Braidwood Station, Units 1 and 2
Facility Operating License Nos. NPF-72 and NPF-77
NRC Docket Nos. STN 50-456 and STN 50-457

Subject: Pressure and Temperature Limits Reports (PTLRs), Revision 2, Braidwood Station, Units 1 and 2

List of Changes to the Unit 1 PTLR

Attachment 2
List of Changes to the Braidwood Unit 1 PTLR

Figure 2.1
Braidwood Unit 1 Reactor Coolant System Heatup Limitations (heatup rate up to 100°F/hr)
Applicable for the First 14 EFPY
(Without Margins for Instrumentation Errors)

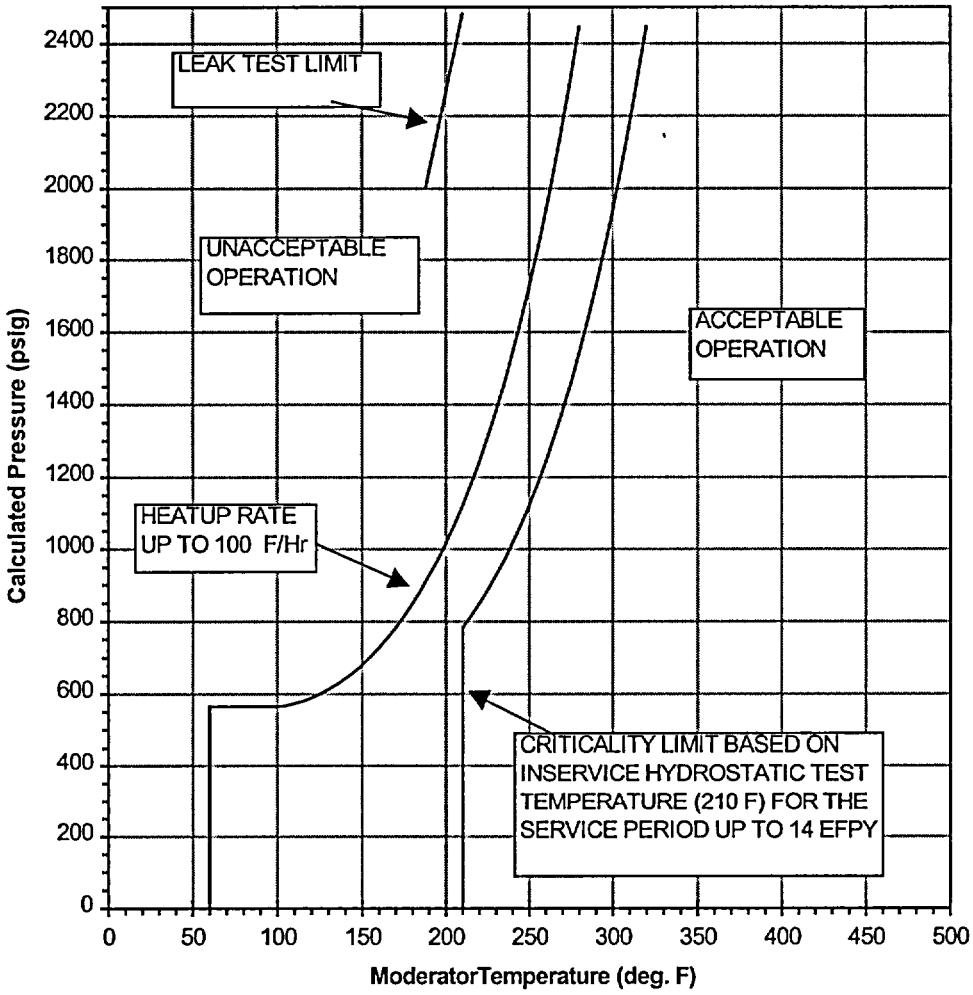
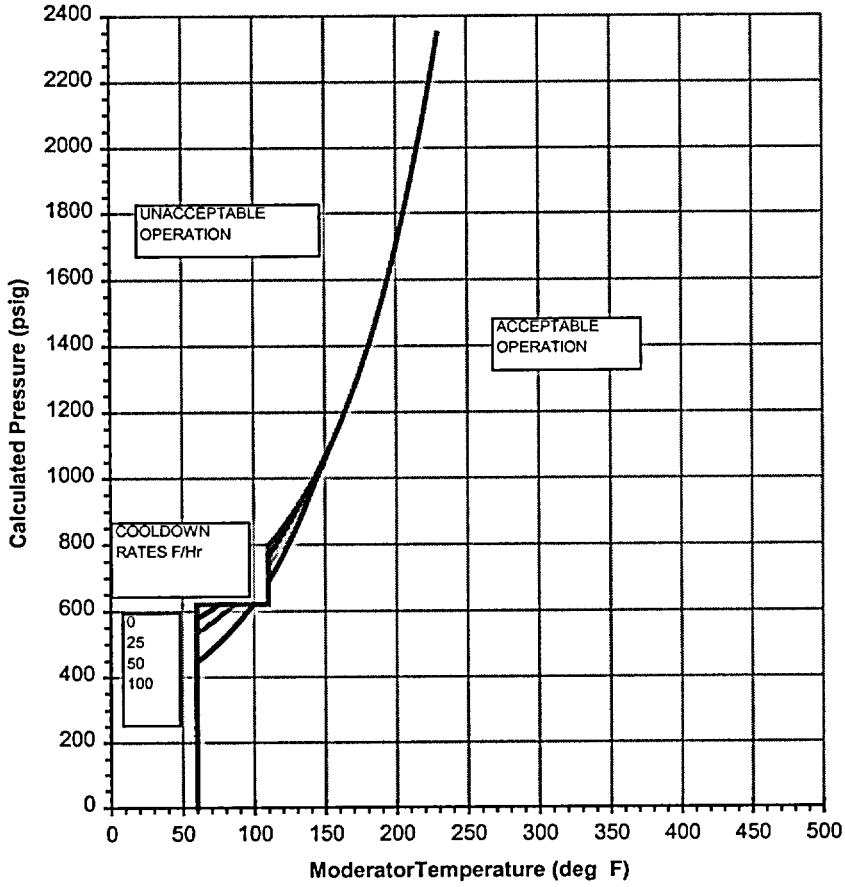
Page	Section	Previous	Revised to	Basis
ii and iii	List of Figures/ Tables	The description of Figures 2.1 and 2..2 and Tables 2.1a and 2.1b describe the heatup rate curve as "using 1996 Appendix G Methodology."	This description is removed.	The Unit 1 PTLR does not use ASME Section XI 1995 edition, 1996 addenda. The Unit 1 PTLR curves are generated using Appendix G of the 1989 Edition of the ASME Section XI Code. The Unit 1 PTLR uses ASME Code Case N-514, "Low Temperature Overpressure Protection," which was later adopted into the 1995 edition with 1996 addenda. See WCAP-14243, "Braidwood Unit 1 Heatup and Cooldown Limit Curves for Normal Operations," Section 6.0.
1	1.0	"This PTLR for Unit 1 has been prepared in accordance with the requirements of TS 5.6.6. Revisions to the PTLR shall be provided to the NRC after issuance."	"This Pressure and Temperature Limits Report (PTLR) for Braidwood Unit 1 has been prepared in accordance with the requirements of Braidwood Technical Specification (TS) 5.6.6, "Reactor Coolant System (RCS) Pressure and Temperature Limits Report (PTLR)". Revisions to the PTLR shall be provided to the NRC after issuance."	Editorial change. Sentence reworded for clarification.
